**TRANSMISSION LINE & SUBSTATION PROJECTS**

**FACILITIES STUDY**

**PID 250 GENERATOR INTERCONNECTION**

## 10. CUSTOMER COMMENTS TO FACILITIES STUDY

Figure 1: Load Flow Analysis for Power Factor Design Requirement

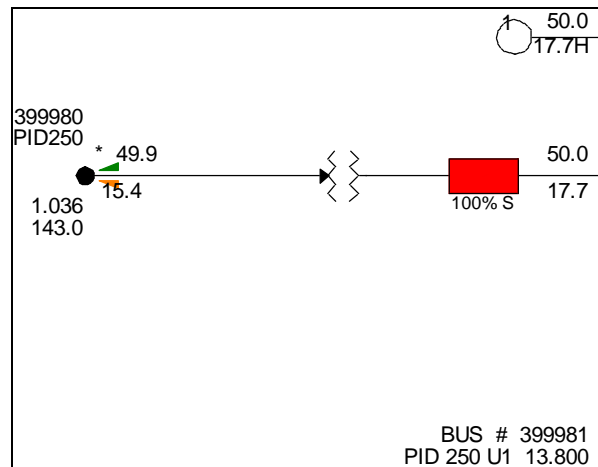
*“Consequently, to avoid overloading the GSU, the maximum reactive power capability of the PID 250 generator is 17.7 MVAR when operating at a real power output of 50 MW. After accounting for the losses through the GSU, the net reactive power injection at the transmission grid is 15.4 MVAR (Figure 2). This is less than the Power Factor Design Criteria of .95 lagging power factor, which would calculate to 16.67 MVAR injected at the point of interconnection for a 50 MW plant.”*

**GDS Comment 01/09/2012:** Comment in conjunction with Comment 5. We suggest eliminating the entire paragraph.

*“In order to meet the 0.95 lagging power factor requirement, the generator step-up transformer must be rated to handle at least 55 MVA.”*

**GDS Comment 01/09/2012:** This statement should be reworded such as "In order to meet the 0.95 lagging power factor requirement, the generator step-up transformer must be rated to accommodate a maximum output of the plant".

**Entergy Response:** Entergy agrees with the ICT. Section 3.2.1.2 of Attachment N to the Entergy Tariff states that for ERIS service, the Transmission Provider shall perform a reactive power analysis at the Point of Interconnection as it relates to the Transmission System. This paragraphs details the results of this analysis.

**Entergy Response:** This sentence concludes the reactive power analysis and should remain in the report. Based on the MW amount of ERIS service

requested and the GSU impedance data received, Entergy concludes that at least a 55 MVA rated GSU is required for this interconnection.
